Agenda  
Lane Cove Local Planning Panel Meeting  
27 March 2024

**Lane Cove Local Planning Panel 27 March 2024  
2 MANNS AVENUE GREENWICH**

**Subject:** 2 Manns Avenue Greenwich  
**Record No:** DA23/93-01 - 70444/23  
**Division:** Planning and Sustainability Division  
**Author(s):** Christopher Shortt

**Lane Cove Local Planning Panel Meeting 27 March 2024**  
**266 LONGUEVILLE ROAD, LANE COVE - S4.55 MODIFICATION OF CONSENT**

**Figure 6:** Amended design with sightline corridor retained after 1<sup>st</sup> floor reduced.

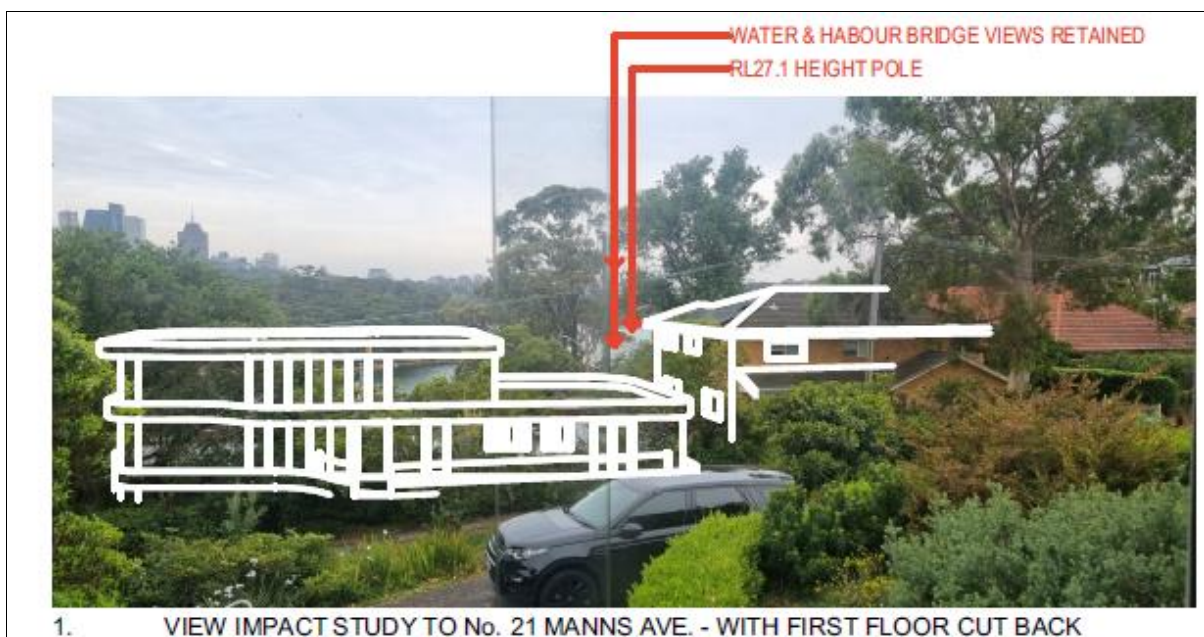
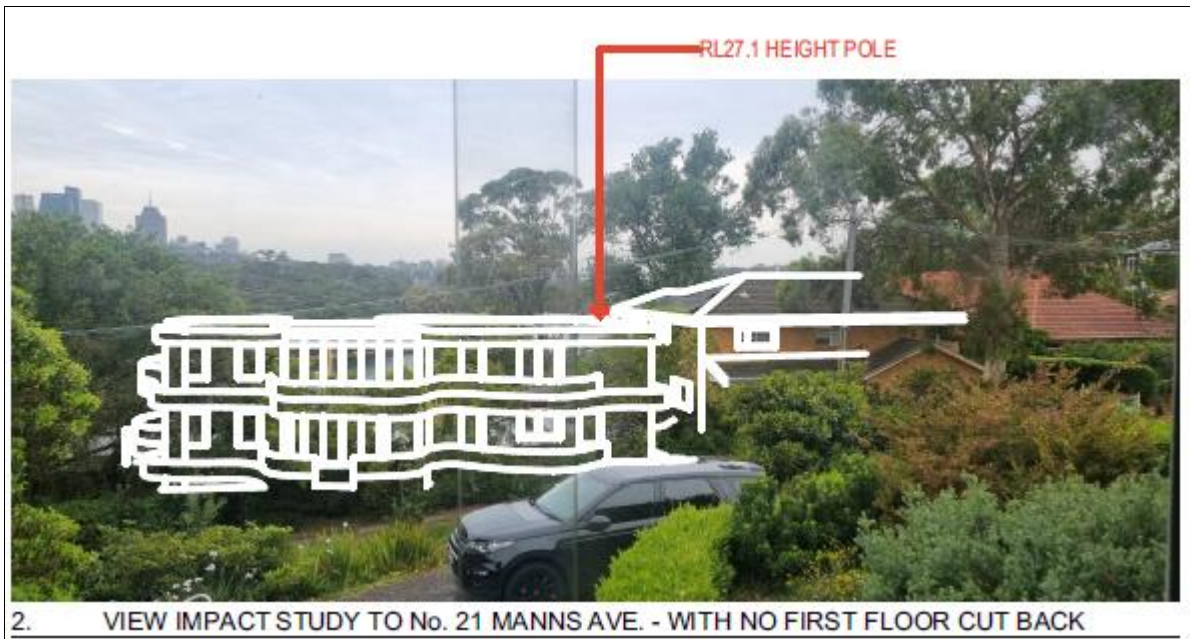
<p><b>Principle 4 - Reasonableness of the proposal:</b></p>	<p><b>Planning Controls:</b> The part of the proposal which affects views relates to the upper level.</p> <p>The proposal complies with the relevant planning controls which define the bulk and scale of the dwelling including:</p> <p><b>FSR:</b> complies with the FSR control of 0.5:1.  <b>HEIGHT:</b> complies with height control. The maximum height is 7.53m and almost 2m below the permitted 9.5m height control.  <b>REAR SETBACK:</b> complies with rear setback line.  <b>SIDE SETBACK:</b> complies with the 1.5m side setback control.</p>
---	---

<p>The tenacity principles require that a more skilful design with the same development potential be explored to check if available.</p> <p><b>Proposed design:</b>          Although the original design complied with the height/FSR and setback controls, the proposal was further modified to reduce its overall bulk and scale and allow view corridors for affected sites</p> <p>The 1<sup>st</sup> floor setback was increased from 1.5m to approximately 10m from the southern boundary with 4 Manns Avenue.</p> <p>The amended design increased the 1<sup>st</sup> floor setback to 10m from the southern boundary. The amended design of the 1<sup>st</sup> floor results in a section of the building being single-storey. The height would be reduced to approximately 4.75m above natural ground level for approximately 30% of the width of the Manns Avenue frontage.</p> <p>Given that a maximum 9.5m height control, can be considered for the site, a building with heights between 4.75m – 7.53m is considered to be a sympathetic design.</p> <p>The amended design would retain a south-eastern view corridor enjoyed by 21 Manns through to the Lane Cove River and Sydney Harbour bridge. However, the revised proposal would still impact water view corridors directly east to Gore Cove. In terms of view hierarchy of views:</p> <ul style="list-style-type: none"> <li>• The Sydney Harbour Bridge view is classified as an iconic view and is <u>retained</u>.</li> <li>• Part of water views to Gore Cove would be impacted, but is considered secondary and overall view sharing is retained.</li> </ul> <p>It is noted that the approved but yet-to-be-built 1<sup>st</sup> floor addition at 21 Manns at RL 30.65 is likely to retain some water views across to Gore Cove as well as City views to the harbour Bridge.</p> <p>The amendments are considered to be result in more skilful outcome as they are specifically designed to protect iconic views for the affected neighbours.</p>

Figure 7: Original design with full 1<sup>st</sup> floor envelope.
